**Statement of Response to ABP's Opinion
in relation to ABP. Ref.: 312243-21**

A Proposed Strategic Housing Development

**Carrickmines Great,
Glenamuck Road South,
Dublin 18**

John Spain Associates

Figure 2.1: Extract of Land Use Zoning Map 9 of the Development Plan with approximate site location identified

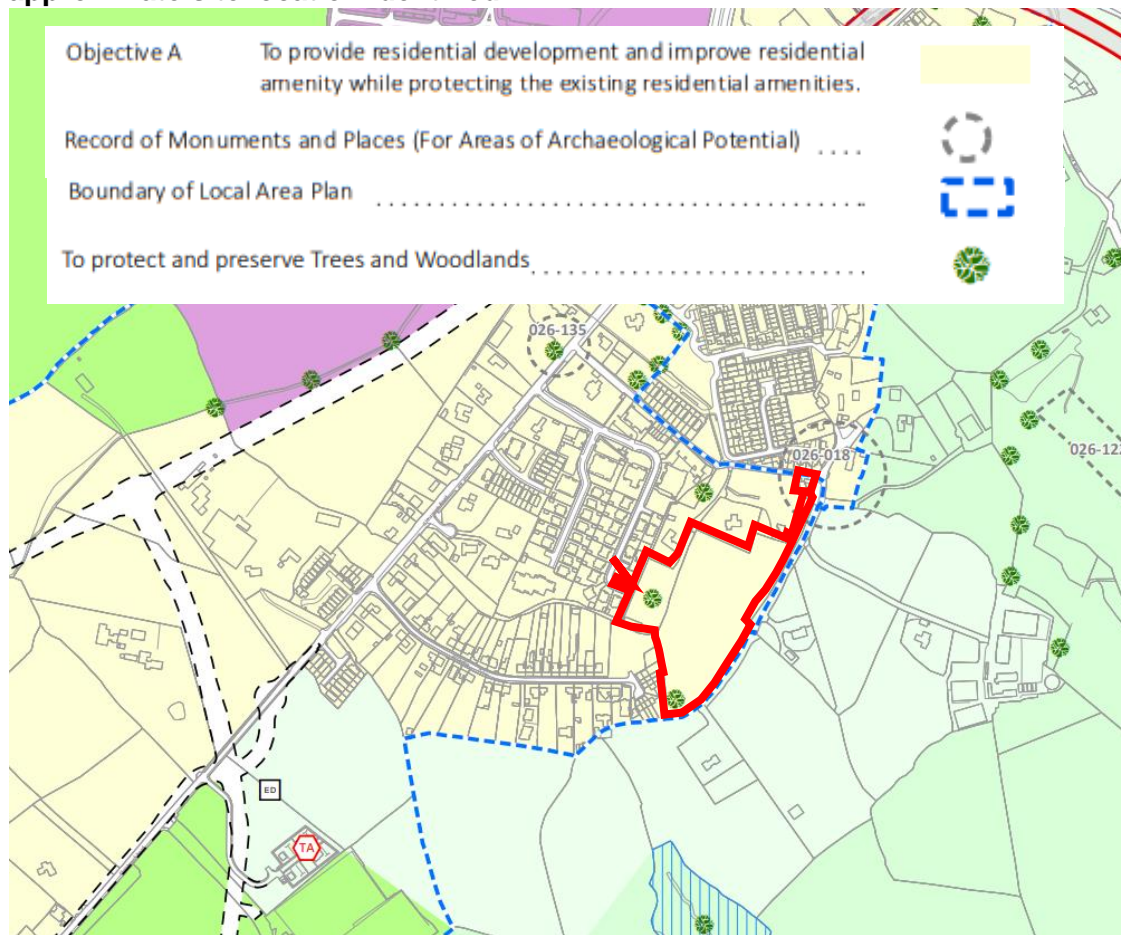
1. *"In accordance with section 5(5)(b) of the Act of 2016, as amended, any application made on foot of this opinion should be accompanied by a statement that in the prospective applicant's opinion the proposal is consistent with the relevant zoning objectives of the development plan for the area. Such statement should have regard to the development plan or local area plan in place or, likely to be in place, at the date of the decision of the Board in respect of any application for permission under section 4 of the Act."*

- As illustrated in Figure 2.1 below the site is zoned Objective A – “To provide residential development and improve residential amenity while protecting the existing residential amenities.” in the Dun Laoghaire Rathdown County Development Plan 2022-2028 (hereinafter ‘Development Plan’).
- Residential use is permitted in principle under this zoning designation. Childcare service use is also permitted in principle, subject to the use not having adverse effects on the ‘A’ zoning objective. The proposal is considered to be fully consistent with the land use zoning objective.
- As set out in OMP’s documentation and drawings, and other relevant reports, the scheme layout and massing has been designed to protect the amenities of adjacent relevant properties.

Figure 2.2: Extract from Proposed Landscape Detail sheet

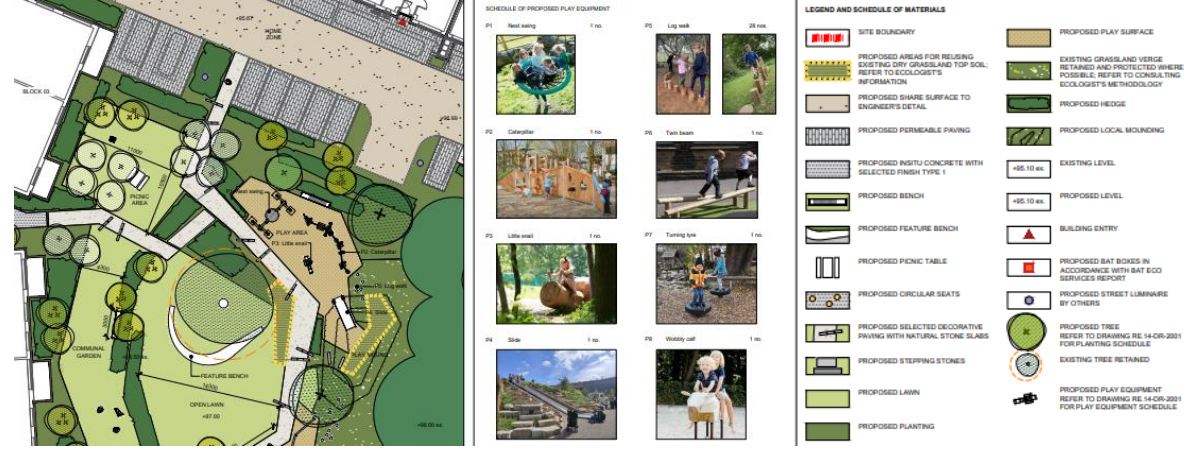
7. “Detailed landscape drawings that illustrate hard and soft landscaping, useable communal open space, meaningful public open space, quality audit and way finding. The public open space shall be useable space, accessible and overlooked to provide a degree of natural supervision. Details of play equipment, street furniture including public lighting and boundary treatments should be submitted.”

The report and drawings illustrate the full details of the hard and soft landscaping, communal open space and public open space to be provided as demonstrated in the extract from the detail sheet provided at Figure 1.1 below.

As outlined in the Landscape Design Rationale Report and as shown on the landscape drawings, the main open space is located at the south-east part of the site, formed by strong architectural enclosure with passive surveillance from apartments and houses. The location of the main open space allows for the maximum retention of the vegetation to the eastern boundary as well as the provision of verges with pollinator species. The main open space includes natural play equipment, local mounding and a large central lawn area.
